5.5	LATE REPORT: NO. 131 (LOT 282; D/P: 2503) COOGEE STREET, MOUNT HAWTHORN - PROPOSED CARPORT AND AWNING ADDITION TO SINGLE HOUSE
------------	---

To consider an application for development approval for a carport and awning addition to a single house at No. 131 Coogee Street, Mount Hawthorn (subject site).

Verge Tree

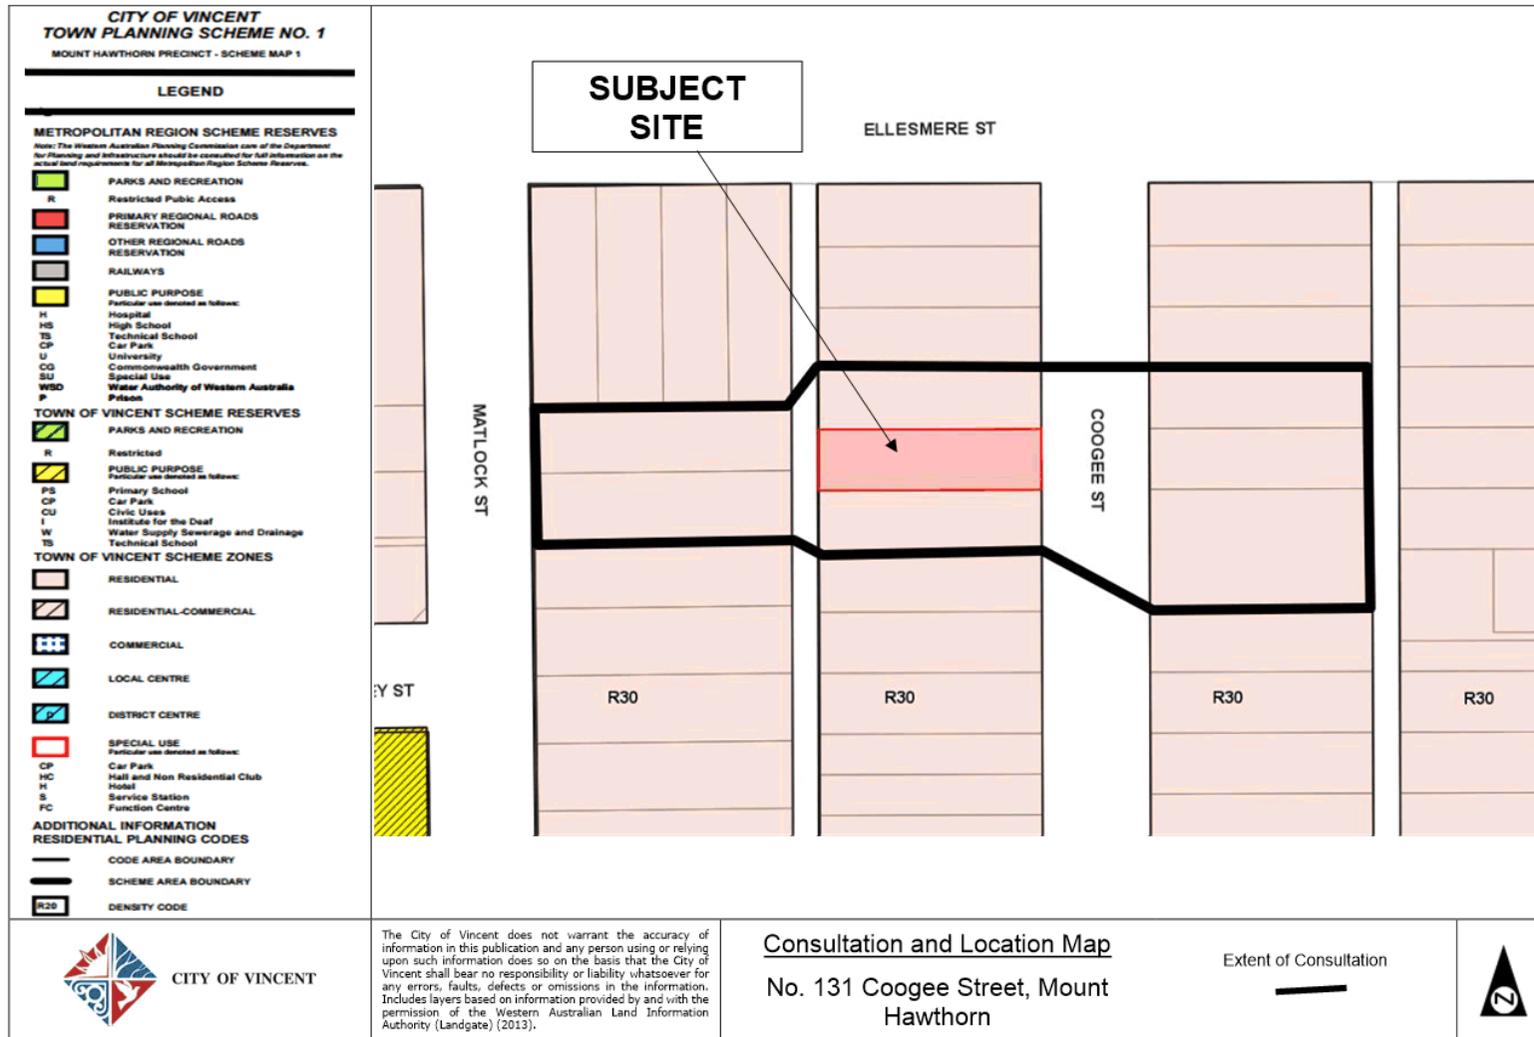
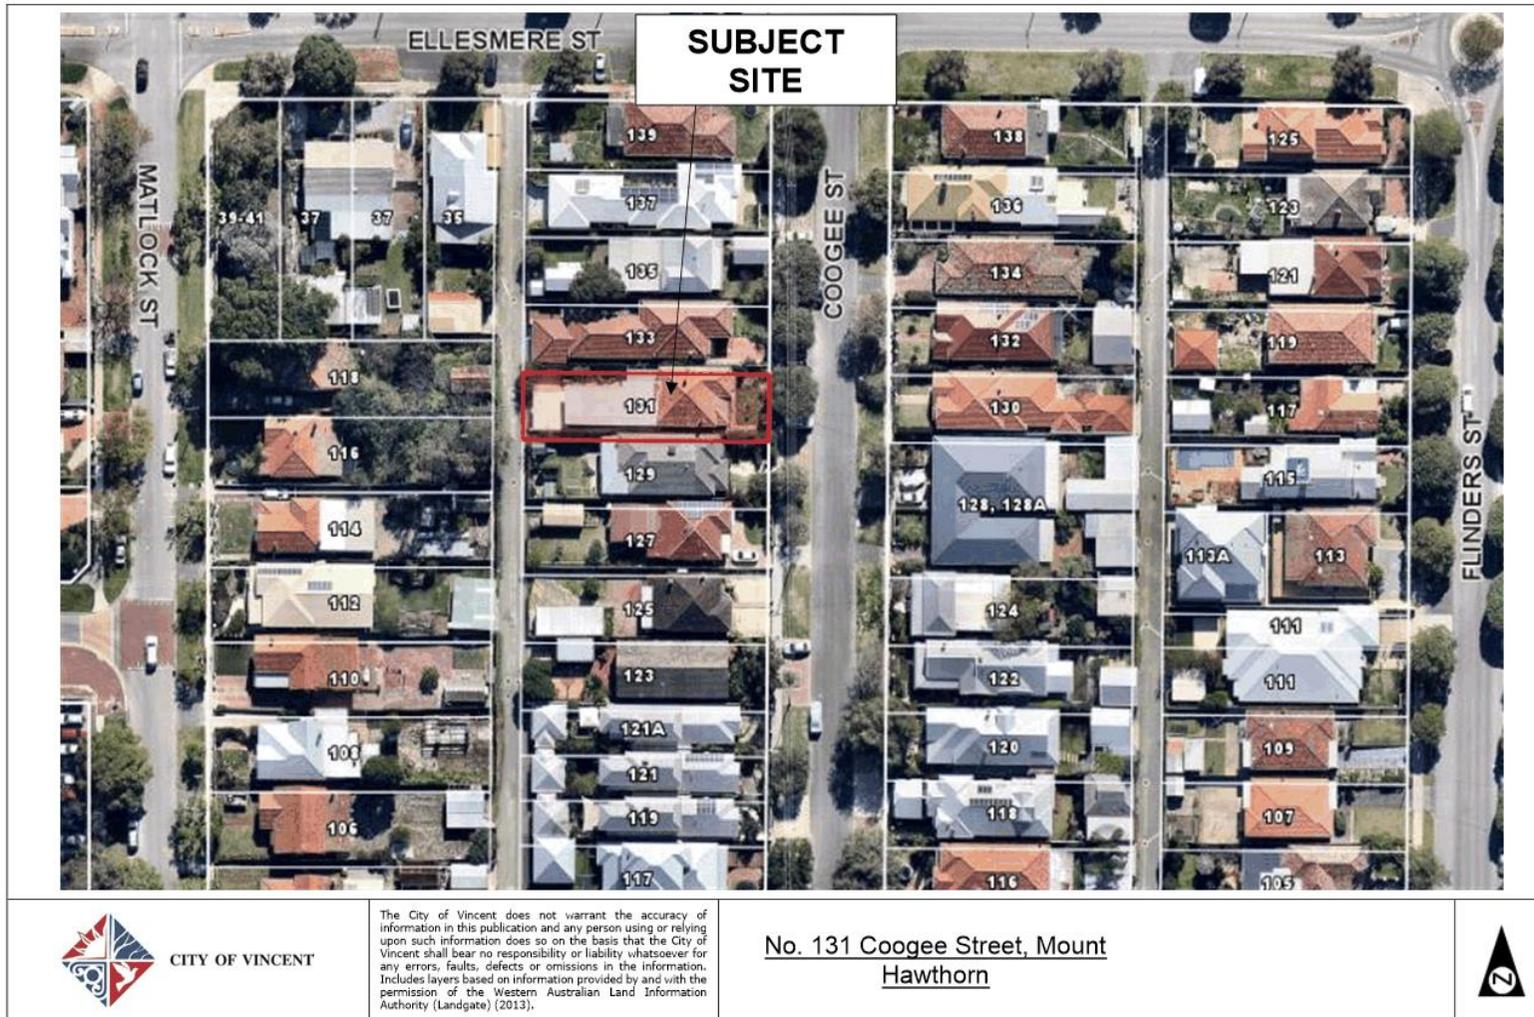
The refusal of the previous carport application was partly on the basis of the impact the proposed crossover would have on the health of the existing verge tree. The carport and crossover have been relocated as part of this application to the southern side of the lot. The crossover is now located 2.5 metres from the base of the existing verge tree. The City's Policy No. 2.2.4 – Verge Treatments, Plantings and Beautification, requires a minimum clearance of 0.5 metre to any existing tree in the verge and where an existing tree will be within 1.5 metres of a proposed crossover, advice shall be obtained on the future size of tree and the advisability of it being retained. On the basis of the above, the clearance of 2.5 metres between the proposed crossover and the base of the existing verge tree is considered sufficient to ensure the health of the tree.

SITE PLAN SCALE: 1:200

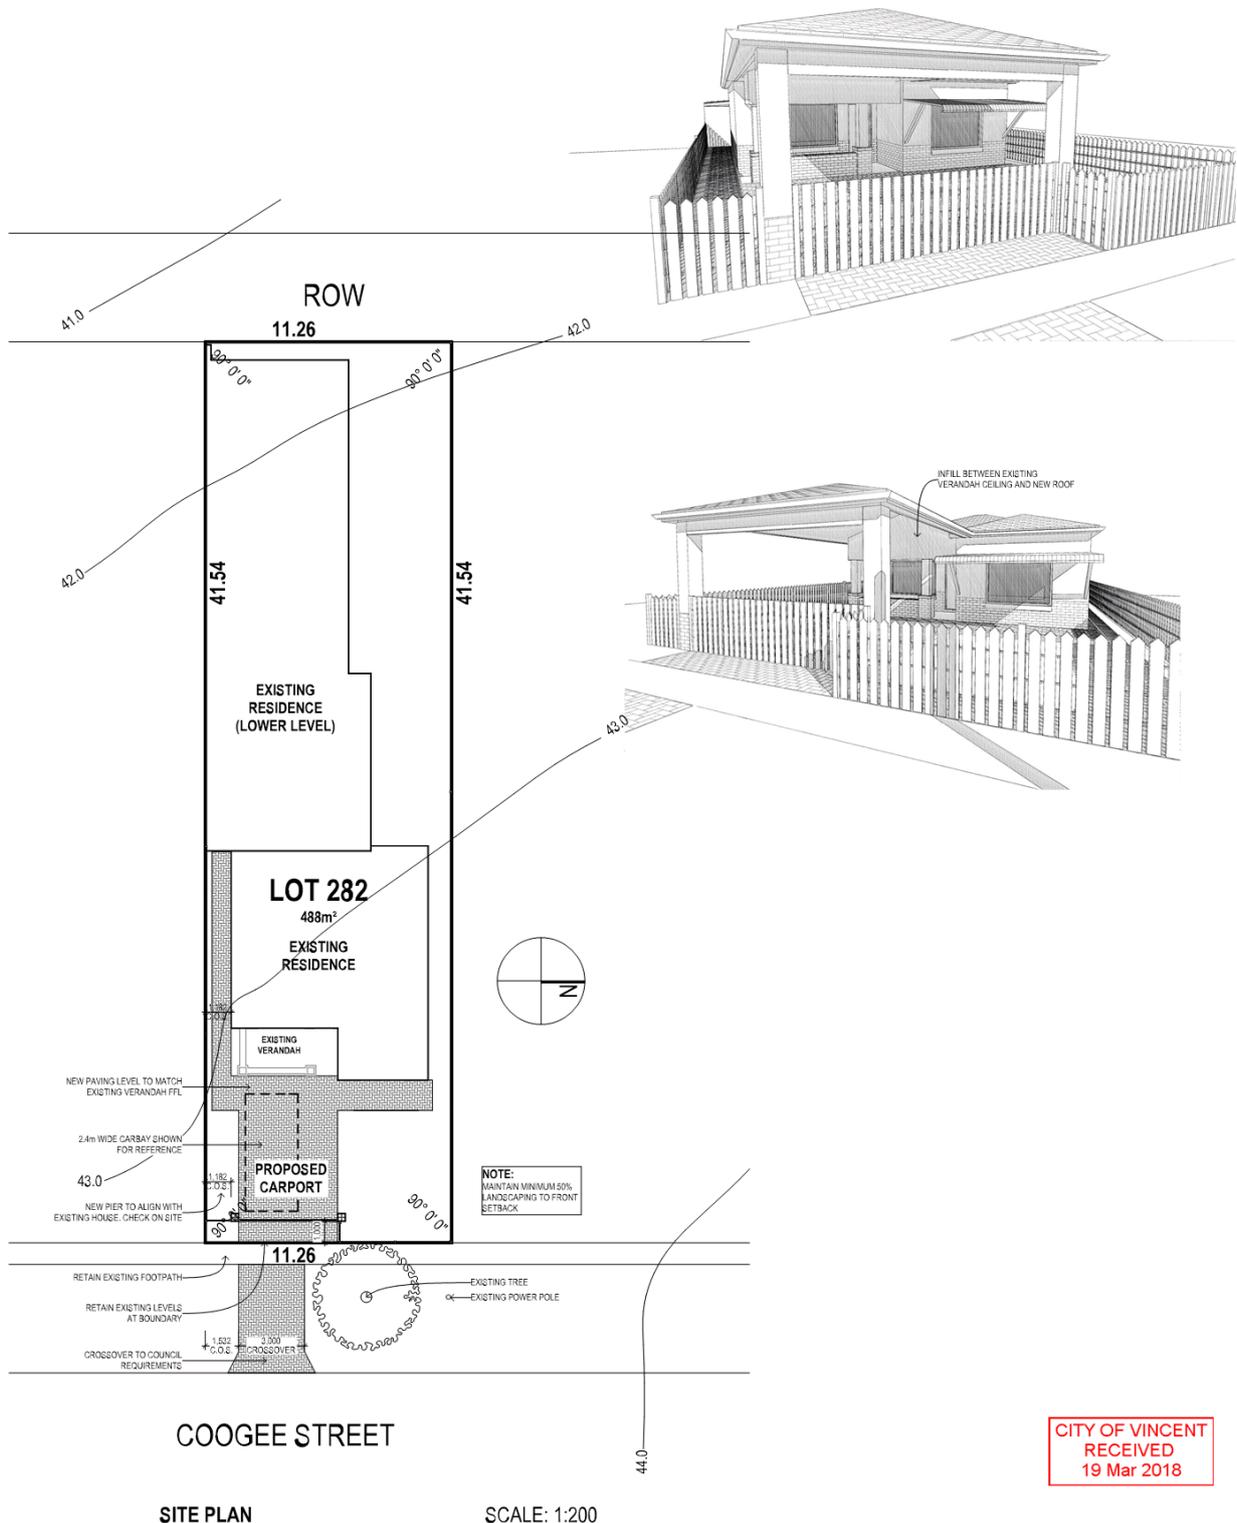
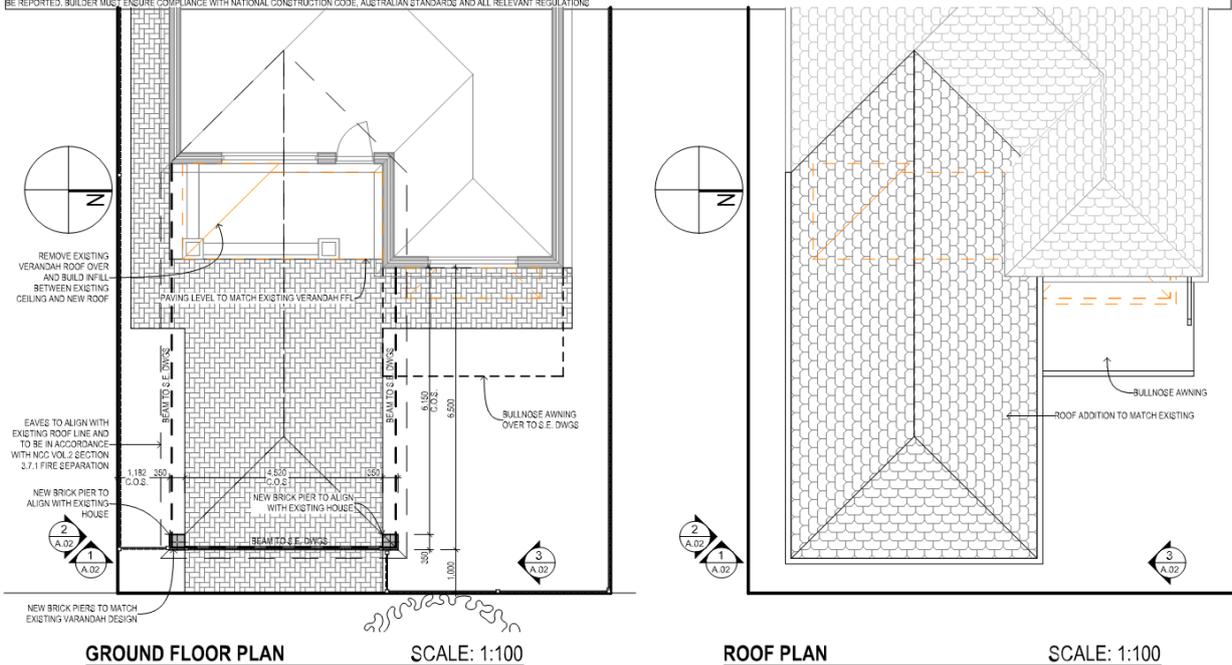
The proposal seeks approval for a 1.2 metre setback to the southern lot boundary in lieu of the 1.5 metres set under the deemed-to-comply standards of Clause 5.1.3 of the R-Codes.

The proposal seeks approval for a 1 metre setback to the Coogee Street boundary in lieu of the minimum 3.4 metres required under the deemed-to-comply standards of Clause 5.2.1 of the R-Codes and Clause 5.7 of Policy No. 7.1.1.

The proposal seeks access from Coogee Street in lieu of the rear right of way set as a deemed-to-comply standard under Clause 5.3.5 of the R-Codes.

Policy No. 7.1.1 and the R-Codes permit the awning to project no more than 1 metre in to the street setback area provided that the total width of the projection does not exceed more than 20 percent of the frontage of the lot. On this basis, the awning is permitted to be setback a minimum of 5.8 metres from the street boundary provided it has a width of no more than 2.2 metres. The proposed awning is setback 5 metres from the street boundary with a width of 4.1 metres and as such does not meet the deemed-to-comply standards of Clause 5.1.2 of the R-Codes and Clause 5.2 of Policy No. 7.1.1. On this basis, the proposed setback of the bullnose awning is required to be considered against the corresponding design principles.

- The addition of both the bullnose awning and the proposed carport bring the street setbacks of the buildings to 1 metre and 5 metres in lieu of the 6.8 metre average that is maintained by the adjoining five dwellings. This creates an area of intrusion into the required street setback area of 36 square metres which is considered excessive. Should the existing tiled awning remain on-site, it will create a significant area of open space and landscaping adjoining the proposed carport which will reduce the scale and bulk of the development on the subject site as well maintaining a consistent street setback of the northern portion of the dwelling with the surrounding properties.

1. This approval is for the proposed Carport Addition to Single House only, as shown on the plans dated 19 March 2018. No other development forms part of this approval;
2. The proposed bullnose awning does not form part of this development approval;
3. No verge trees shall be removed without the prior written approval of the City. The verge trees shall be retained and protected from any damage including unauthorised pruning, to the full satisfaction of the City;
4. All stormwater produced on the subject land shall be retained on site, by suitable means to the full satisfaction of the City; and
5. The carport door/gate shall not exceed 1.2 metres in height and shall be a minimum of 50 percent visually permeable in accordance with Clause 5.2.1 of the Residential Design Codes.

GROUND FLOOR PLAN

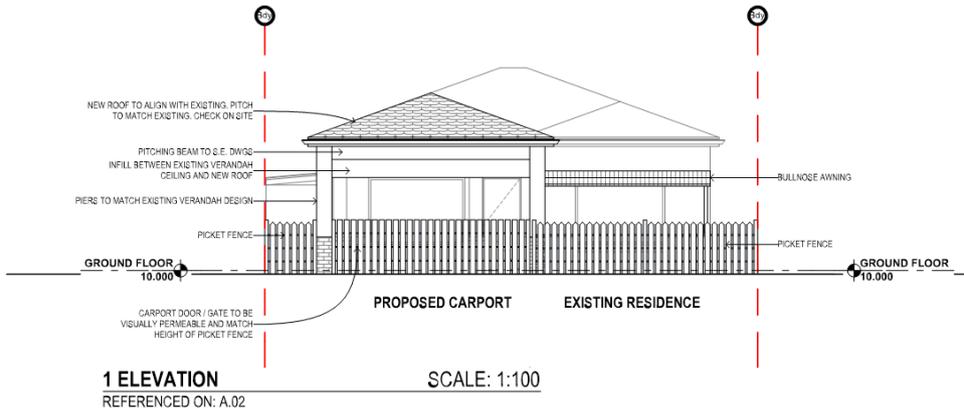
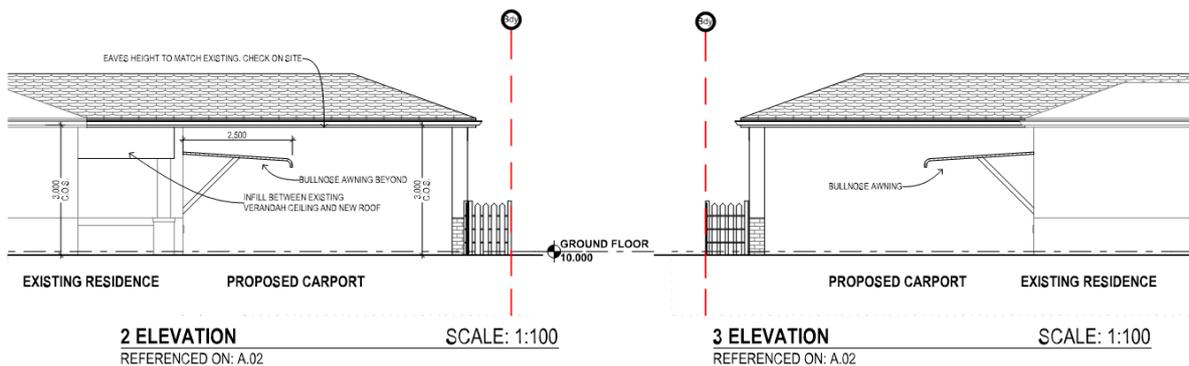
- The carport is fully open on the southern and northern boundary sides and open above 1.2 metres in height fronting the street. On this basis, clear sightlines will be maintained along the street;

- The door/gate to the carport is open above 1.2 metres in height and indicated to be 50 percent visually permeable. On this basis, the proposed carport will not obstruct views of the dwelling from the street or views of the street from the dwelling. A condition of approval is also recommended in order to ensure that the carport door is constructed no higher than the existing picket fence and to be a minimum of 50 percent visually permeable; and

In addition to the proposed carport, the application is proposing the removal of an existing awning (approximately 0.5 metres deep and 3 metres wide) with a bullnose awning of 2.5 metres deep and 4.1 metres wide. The applicant has noted the reasons for removal of the existing awning and replacement with the bullnose awning as follows

- The proposed carport and bullnose awning will result in the removal of the existing tiled verandah roof and tiled awning located on the southern and northern side of the dwelling. These are considered to be significant design elements of the existing dwelling which contribute to the character of the established streetscape. In the SAT decision on the previous carport application for this site, the SAT noted that the removal of the existing awning over the window of the front room involves a removal of a design element which makes some contribution to the streetscape and cited this as one of the reasons for refusal;

- The materials used for the bullnose awning are not consistent with the materials of the existing dwelling or the dwellings of a similar type and character within the surrounding streetscape. As such, the bullnose awning is considered to detract from the character of both the dwelling and established streetscape; and
